Product/Process Change Notice (PCN)

PCN_IndMAIA_784738356xxx_Additional Mechanical
 Dimension_20170330.doc

Product Affected: WE-MAIA 78438356xxx (size 4020)

PCN Date: 01.05.2017

Picture:

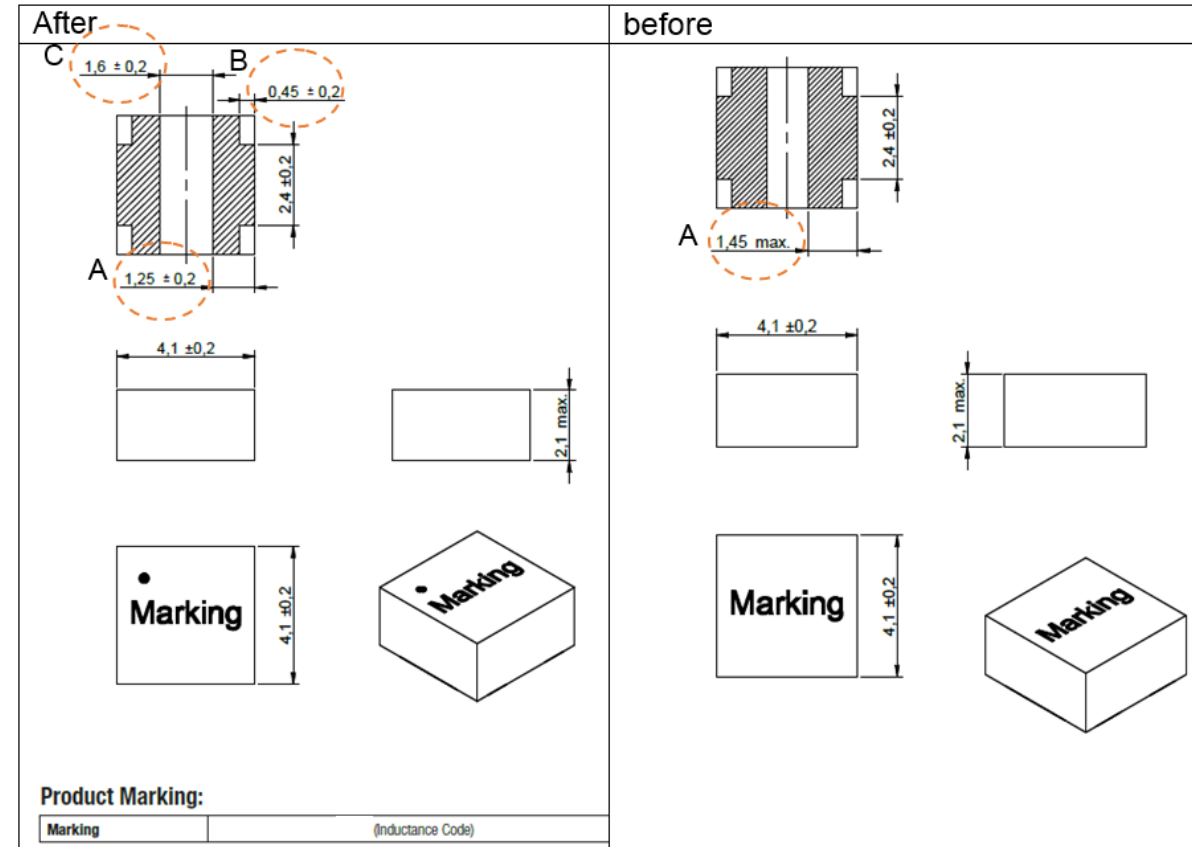
For the purpose of a datasheet information enlargement, Würth Elektronik will implement additional mechanical dimensions, the product marking code as well as the start of winding information into the specification. This change doesn't affect the mechanical properties of the parts itself.

Due to this change the following parts of the dimension are affected:

Dimension	after	before
A	1.25 +/- 0.2 mm	1.45 max.
B	0.45 +/- 0.2 mm	N.A
C	1.60 +/- 0.2 mm	N.A
All others	Remain without change
